STAFF REPORT	
COMMUNITY DEVELOPMENT DEPARTMENT

SUBJECT: Kleiner Adjacent Subdivision – PFP ([H-2023-0059](#)) & ALT (A-2024-0009)

LOCATION: 1730 N. Records Way at the northeast corner of N. Records Way and E. Fairview Ave., in the SW 1/4 of Section 4, T.3N., R.1E.

Combined preliminary and final plat consisting of two (2) building lots on 9.88 acres of land in the C-G zoning district.

B. Final Plat (dated: 11/7/23)

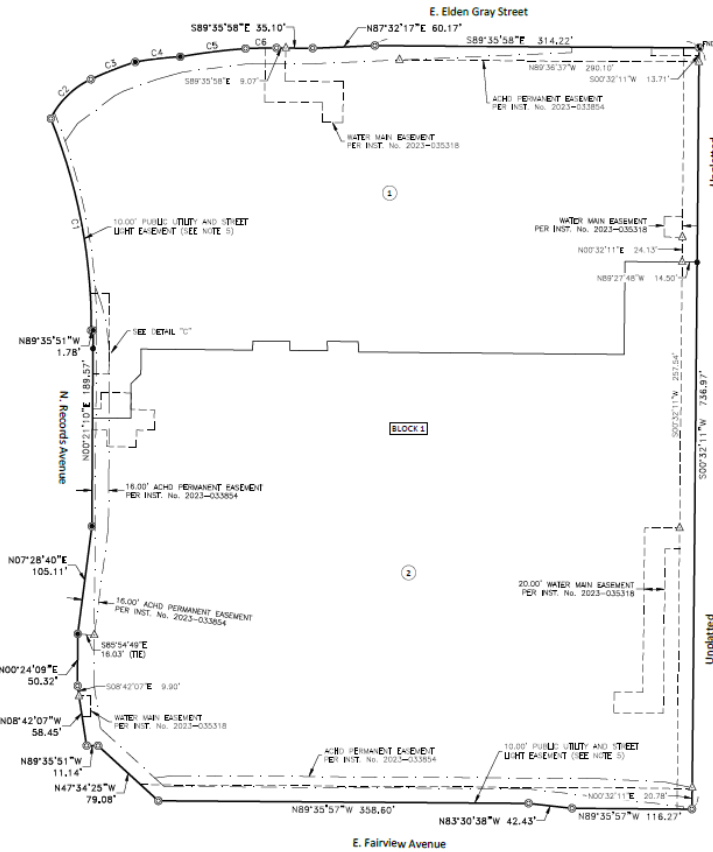
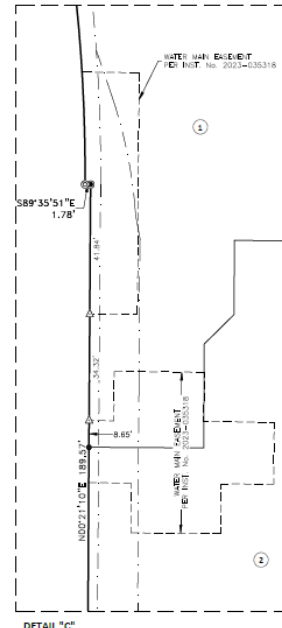
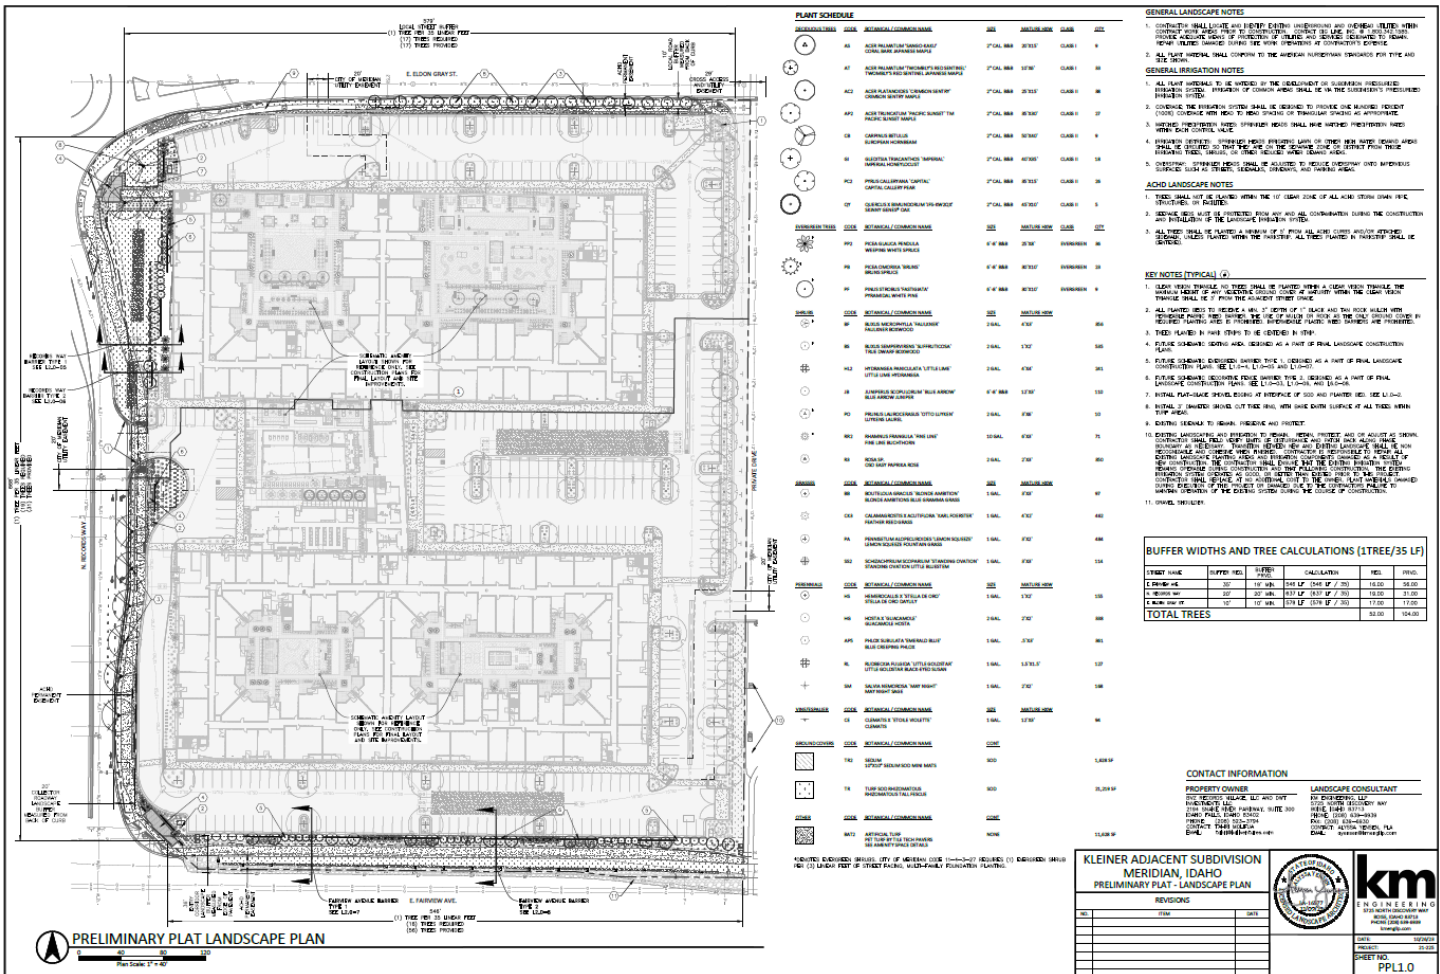
1.1 The final plat submitted for City Engineer signature shall include the following revisions:

- a. Depict street buffers in common lots or dedicated buffer easements, maintained by the property owner or business owner's association, as set forth in UDC [11-3B-7C.2a](#)

- b. Widen the street buffer along Fairview Ave. to a minimum 35-feet in accord with the minimum standards in UDC [11-2B-3](#). An additional 2-feet shall be added to the width of the buffer along Fairview totaling 37-feet if wheel stops aren't provided in abutting parking spaces as set forth in UDC [11-3C-5B.4](#). *If an alternative compliance application will be requested for a reduced buffer width, it should be submitted to the Planning Division prior at least 15 days prior to the City Council hearing.*

- c. Depict a cross-access ingress/egress easement on the plat granting access to the abutting property to the east (Parcel #S1104438755) for use of the existing shared driveway; or, submit a separate copy of a recorded agreement to the Planning Division with the final plat for City Engineer signature or prior to issuance of the first Certificate of Occupancy for the site, whichever occurs first.

- d. Include a note granting a blanket cross-access and cross-parking easement between the proposed lots.
- e. Include a note that states all common areas and site amenities will be shared between the two (2) lots/properties and maintained by the business owner's association for the development.

- e. The minimum width of parkways planted with Class II trees is 8-feet; the planter width may be reduced to 6-feet if there are root barriers that meet the standards in UDC [11-3A-17E](#); revise plans accordingly.

- f. Graphically depict a 14-foot wide public pedestrian easement for the multi-use pathways along E. Fairview Ave. and N. Records Way; include the instrument number of the recorded easement.

- g. Drainage and utility easements shall be noted on the final plat that benefit/serve both of the proposed lots.

C. Landscape Plan (dated: 11/7/23)

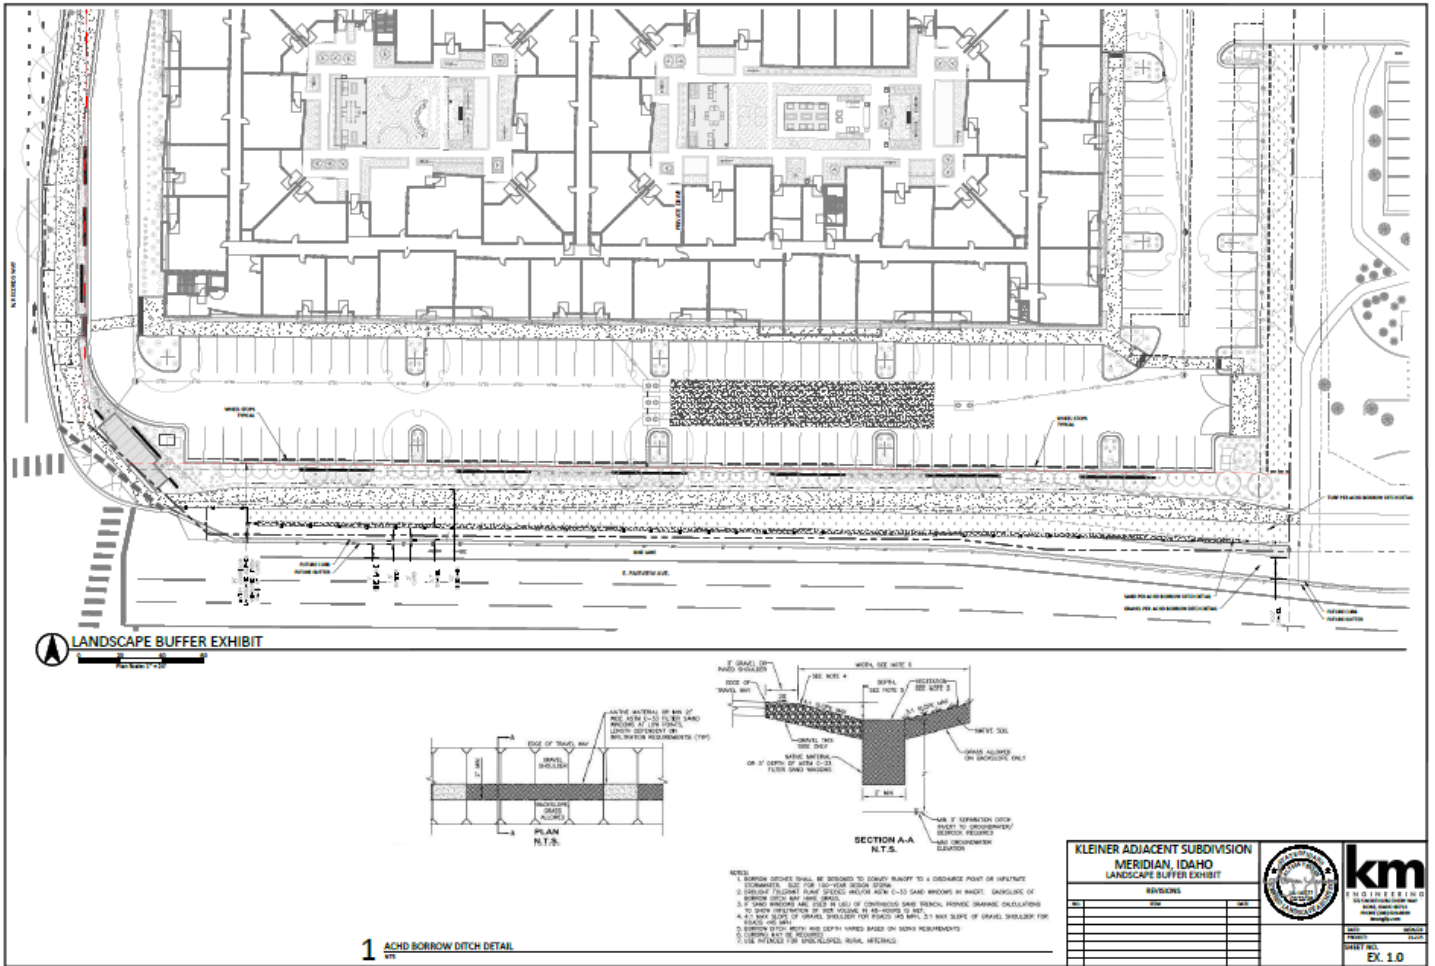
1.2 The landscape plan submitted with the final plat for City Engineer signature shall include the following revisions:

- a. The minimum width of parkways planted with Class II trees is 8-feet; the planter width may be reduced to 6-feet if there are root barriers that meet the standards in UDC [11-3A-17E](#); revise plans accordingly.
- b. Widen the street buffer along Fairview Ave. to a minimum 35-feet in accord with the ~~minimum~~ standards in UDC [11-2B-3](#). ~~An additional 2-feet shall be added to the width of the buffer along totaling 37-feet if wheel stops aren't provided in abutting parking spaces as set forth in UDC [11-3C-5B.4](#).~~ The entire buffer shall be vegetated in accord with the standards listed in UDC [11-3B-7C.3](#), unless otherwise approved by City Council with the alternative compliance request.

Note: A reduced buffer width of 16 feet was previously approved through alternative compliance [A-2022-0085](#) along a 145-foot long section adjacent to the right-turn lane along N. Records Way.
